Subject: AP1000 COL Response to Request for Additional Information (SRP 5.3.1)

Response to Request for Additional Information on SRP Section 5.3.1

AP1000 TECHNICAL REPORT REVIEW

RAI Response Number: RAI-SRP5.3.1-CIB1-01
Revision: 0

Figure 5.3-4
AP1000 Reactor Vessel Surveillance Capsules Locations

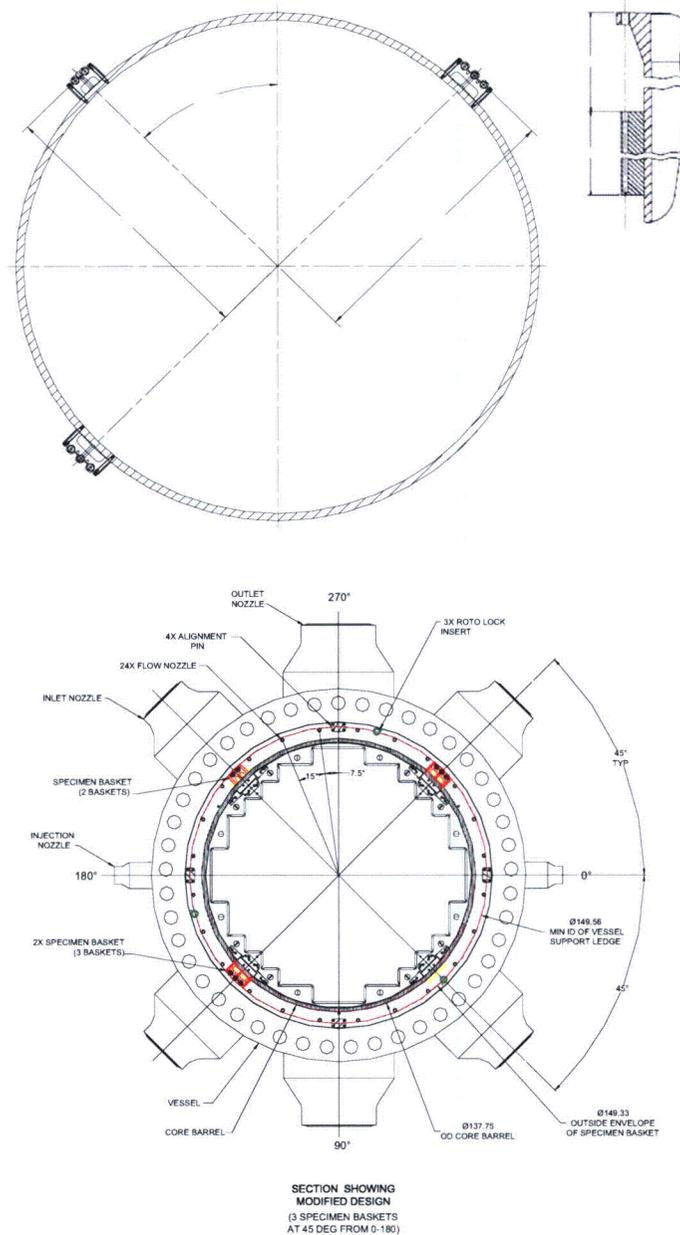
- the azimuthal locations of the capsules (in degrees) and the basis for these locations (as described in APP-GW-GLR-023, Revision 0)
- the calculated lead factors (as described in APP-GW-GLR-023, Revision 0)
- Figure 1, "Surveillance Capsule Azimuthal Location," from APP-GW-GLR-023, Revision 0

Please provide a response describing the information (including the information described above) Westinghouse plans to include in TR134 for incorporation into the next revision to the AP1000 DCD.

The azimuthal locations of the capsules are shown in Figure 1 (from APP-GW-GLR-023) which will be incorporated into DCD Figure 5.3-4. The basis for these locations will be included in DCD subsection 5.3.2.6.

The reactor vessel surveillance program incorporates eight specimen capsules. The capsules are located in guide baskets welded to the outside of the core barrel as shown in Figure 5.3-4 and positioned directly opposite the center portion of the core. The capsules can be removed when the vessel head is removed. To meet the guidelines of ASTM E 185 (lead factors less than three), the specimen guide baskets are located azimuthally near the lowest fluence locations at 135, 225, and 315 degrees. The 45 degree location is also a low fluence azimuthal location, however, there is a Roto-Lock insert for the internals lifting rig which would prevent access for removal of the capsules from the baskets. Therefore, there are no guide baskets at the 45 degree location. Eight specimen capsules are provided by including three guide baskets at the 135 and 315 degree azimuthal locations and two baskets at the 225 degree location.
